TOSHIBA Microcontrollers TLCS-870 Family
TLCS-870/C1 Series

Restrictions on the Voltage Detection Circuit

Datasheet Corrections: Electrical Characteristics of the Power-On Reset Circuit

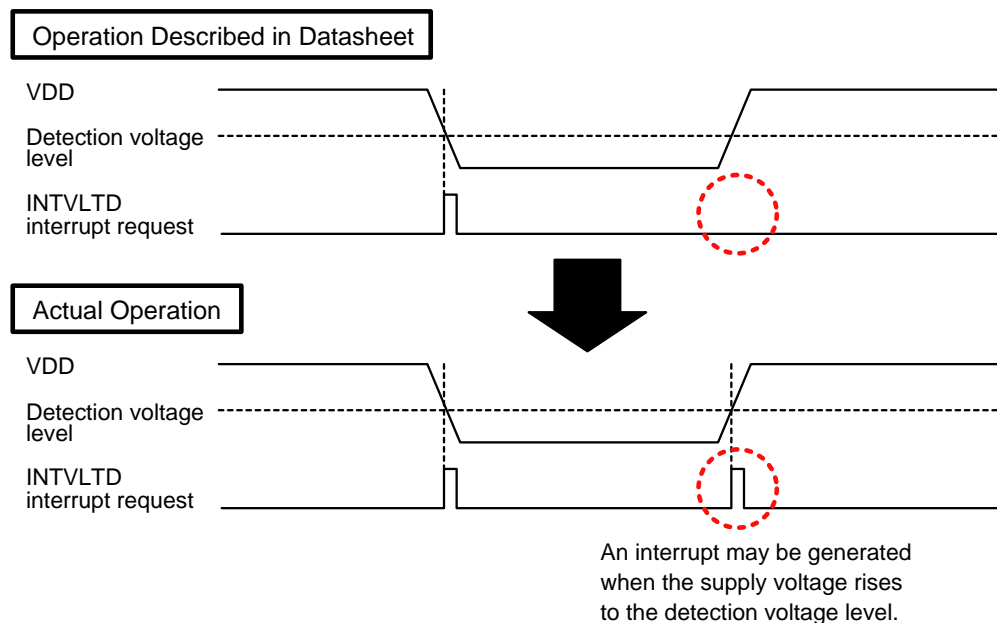
1. INTVLTD Interrupt Request

When interrupt generation is enabled in the voltage detection circuit, an INTVLTD interrupt request may be generated not only when the supply voltage falls to the detection voltage level, but also when it rises to the detection voltage level.

In ICE mode of the In-Circuit Emulator (TMP89C900), no interrupt request is generated when the supply voltage rises to the detection voltage level. Therefore, with products supporting the In-Circuit Emulator (TMP89C900), the interrupt generation operation may differ between the development tool and the actual product.

2. Releasing STOP Mode by Voltage Detection

The SRSS bit in the voltage detection control register 2 (VDCR2) provided for releasing STOP mode by voltage detection cannot be used because it does not function as expected.

1. INTVLTD Interrupt Request

Do not use the INTVLTD interrupt for voltage detection. The voltage level should be regularly checked using other timing such as the execution cycle of the main program. VDCR1<VDxSF> (x=1, 2) can be used to check the voltage level. However, if the operating voltage is near the detection voltage, the VDCR1<VDxSF> value may become unstable. It is recommended that VDCR1<VDxSF> be tested multiple times to determine the voltage level.

2. Releasing STOP Mode by Voltage Detection

Always set VDCR2<SRSS> to "00". Use the STOP pin to release STOP mode.
